## SUBDIVISION REVIEW SHEET

**CASE NO.:** C8-2022-0287

**SUBDIVISION NAME:** Three Hills Apartments

**CITY OF AUSTIN –DEVELOPMENT SERVICES DEPARTMENT  
SUBDIVISION APPLICATION – MASTER COMMENT REPORT**

PRELIMINARY PLAN

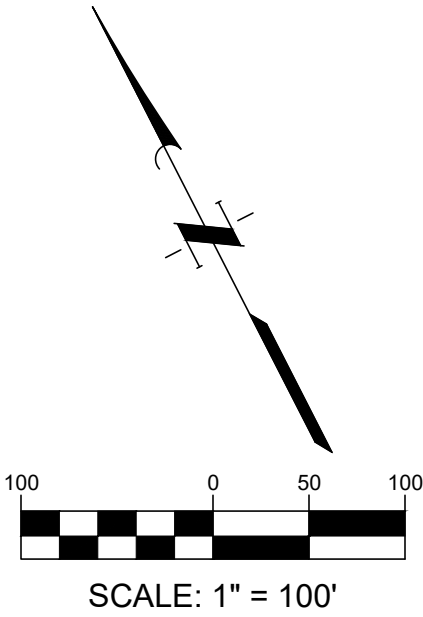
DE1: DCM 1.2.2(D) states, "Stormwater runoff peak flow rates shall not be increased at any point of discharge from a site for the two (2), ten (10), twenty-five (25) and one hundred (100) year storm frequency events". Please provide the information necessary to verify compliance. The Preliminary Plan should match the Engineer's Report.

DE2: Please show all drainage easements on the storm drainage plan. [LDC 25-7-152]

DE3: Show drainage area maps and calculate fully developed condition flows for the offsite contributing areas passing through site. Drainage easements are required for conveyance of offsite flows through the site. [LDC 25-7-151 & 25-7-152]. The Preliminary Plan should match the Engineer's Report.

EV 1 Please explain the purpose of the CWQZ buffer mitigation area. The CWQZ buffer averaging proposal must be delineated to demonstrate compliance with applicable code and criteria. [LDC 25-8, Subchapter A, Article 2; ECM 1.5.2] Delineation includes, but is not limited to, showing the following:

- 1) the existing CWQZ labeled as "ORIGINAL CWQZ";
- 2) the proposed buffer averaged CWQZ labeled as "AVERAGED CWQZ";
- 3) the CWQZ minimum setback; and,
- 4) Provide a table showing the total amount of land area within the existing CWQZ that and the total amount of land area within the proposed buffer averaged CWQZ [LDC 25-8, Subchapter A, Article 2; ECM 1.5.2]

EV 2 The trail must be delineated to demonstrate compliance with regulations and rules for trails in the CWQZ. [LDC 25-8, Subchapter A, Article 7; ECM 1.5.3]. Clarify the width and material of the trail.

Show all existing easements on the preliminary plan with document numbers. Provide document numbers for all public water and wastewater easements within the proposed private streets.

WQ1: Provide a water quality plan using the assumed impervious cover as described in Land Development Code Section 25-8-64. Include all items specified in the Subdivision Application Packet, Page 17. The plan in the Engineering Report should match the one in the Preliminary Plan.

WQ4: Proposed improvements encroach on the Erosion Hazard Zone Buffer established by the Watershed Protection Department. Conduct and provide an analysis in accordance with City of Austin Drainage Criteria Manual Appendix E, Criteria for Establishing an Erosion Hazard Zone. (LDC 25-7-32, DCM Appendix E)

PRIVATE DRIVE CROSS SECTION

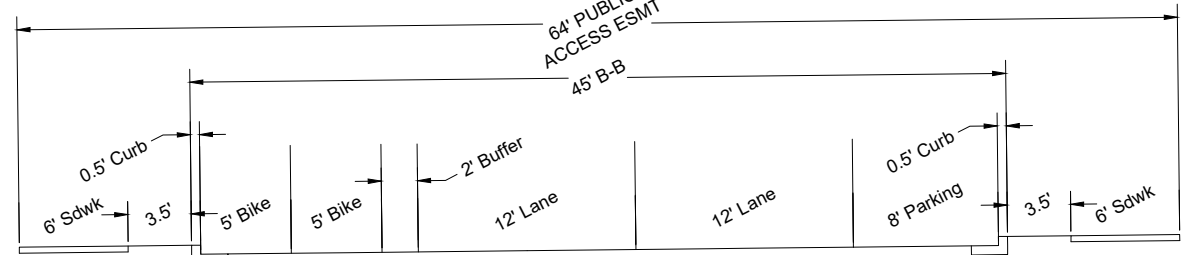
- The proposed Public Access Easements (PAEs) will comply with the City's approved cross section for a Level 1 street.
- The PAEs will provide direct access to a public street (IH 35 Service Road NB).
- The approval of the PAEs does not hinder the implementation of the Austin Strategic Mobility Plan.
- ATD Transportation Development Services staff has not received any expressed concerns from the neighborhood group nor any opposition to the applicant's request for this variance.
